Memorandum

To: Mary Heberling, AICP, Associate Planner, City of Milwaukie
From: Li Alligood, AICP, Senior Planner
Walter Zisette, Providence Supportive Housing
Copies: Lynn Lindgren-Schreuder, Housing Development Center
Gauri Rajbaidya, SERA Architects
Date: May 25, 2021
Subject: Additional Applicant Testimony for File #VR2021-006
Project No.: 19836.100

The applicant, Providence Supportive Housing, submits this additional information in response to public comments submitted between May 11 and May 18, 2021.

Figure 1. Location of Hauck/Croker home relative to the proposed building

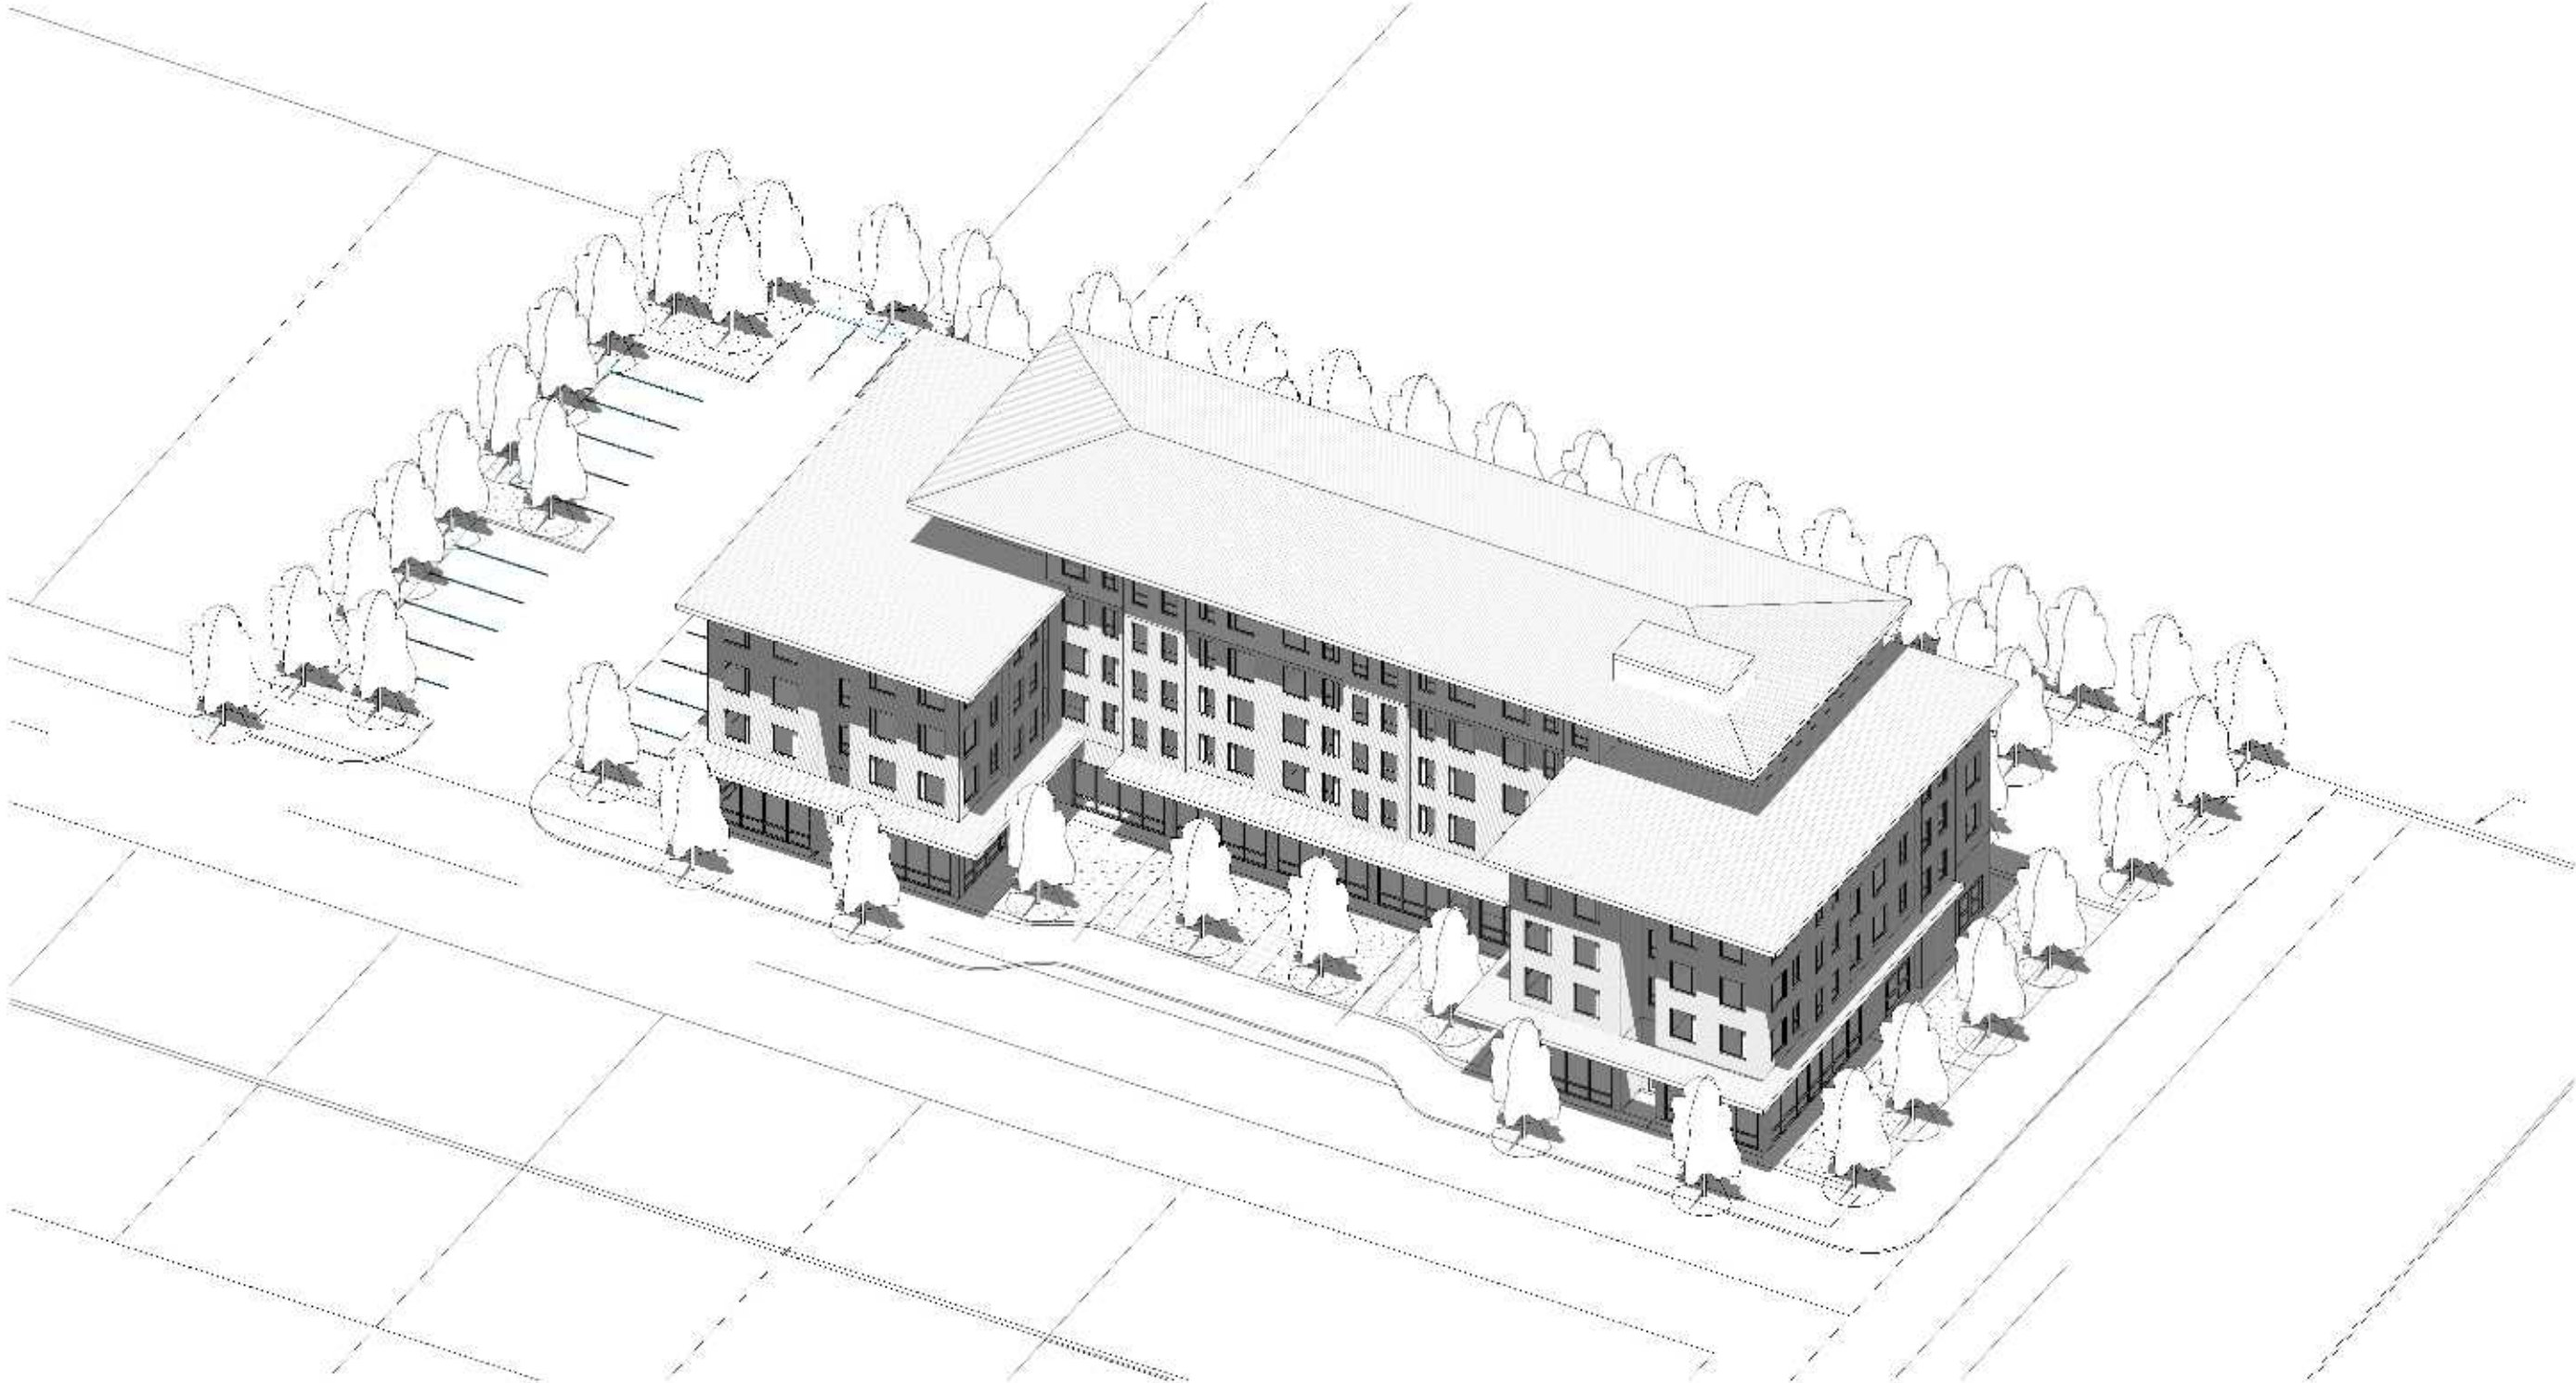
Response to comments from Matt Hauck and Melany Croker, 3425 SE King Rd

- The existing home is located more than 200 ft. northwest of the proposed building site and is separated from the proposed development site by a tall stand of trees and a planned landscaped open space.
- In addition, the proposed building will be located 120 ft. from SE 34th Ave. See Figure 1. It will not cast shade on the Hauck/Croker home.
- The proposed parking lot and access points have been approved by the Planning Commission (File #CU-2021-001).
- As noted in the applicant’s submittal materials and verbal testimony, a traffic impact study will be completed at the time of Site Plan Review. Any identified mitigations will be provided as part of the project. The

development will also rebuild the SE Llewellyn St frontage and SE 34th Ave frontage as part of the project, including a shared bicycle and vehicle travel lane.
